SI B11 14 18
Engine

SERVICE ACTION: N63R ENGINE – CHECK AND REPLACE OIL FEED LINES AND THE MAP THERMOSTAT ELECTRICAL CONNECTOR

This Service Action involves G12 and G30 vehicles produced from February 2017 to January 2018.

Turbocharger oil feed line overview:

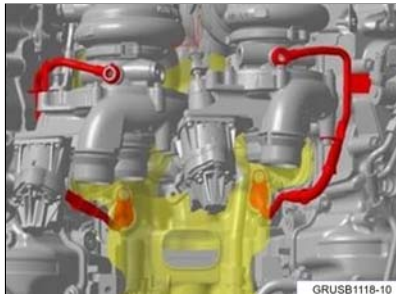
The oil feed line locations are shown with red highlight

1. Stainless steel flexible section. This is the new design and should not be replaced.

2. Black rubber flexible section. This line should be replaced.

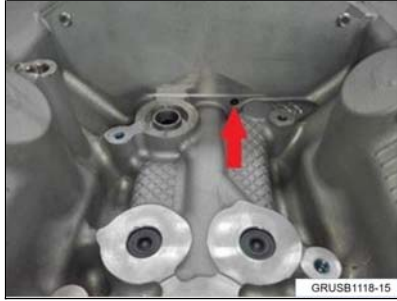
3. Check the exhaust turbocharger oil feed line on bank 2.

If the flexible section of the feed line is made of braided stainless steel (see arrows) then take no further action. **Do not replace the line.**

If the flexible section is black rubber then the oil feed line will need to be replaced.

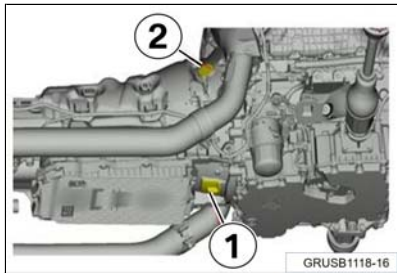
Wipe dry with a shop towel and rinse the residual oil with cleaner via the drain hole and flush it out (see arrow).

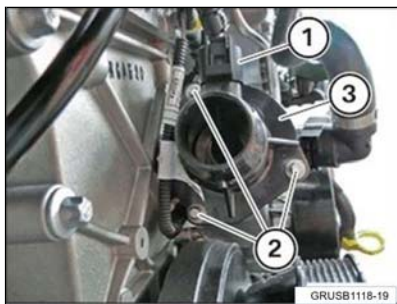
5. If the lower transmission housing also has oil residue present then it has to be cleaned via the opening (1). To do so, remove the sealing cap (1) and sealing cap (2) and flush out the excess engine oil residue. The sealing cap (2) may be located on the left or the right side of the transmission housing.

Reinstall both sealing caps when finished.
